# TECHNICAL BULLETIN

**[Issue No.]** GOT-A-0005-B

**[Title]** Discontinuation of GOT-A900 Series Flash PC Card (A9GTMEM-10MF, A9GTMEM-20MF) and Change of Memory Capacity (A9GTMEM-40MF)

**[Relevant Models]** A9GTMEM-10MF, A9GTMEM-20MF, A9GTMEM-40MF

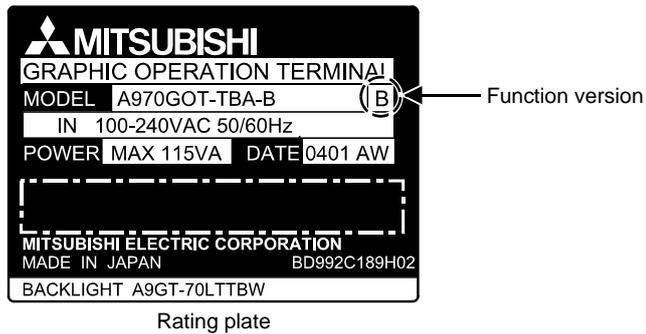
• Checking the version

The function version can be checked on the rating plate on the GOT rear face.
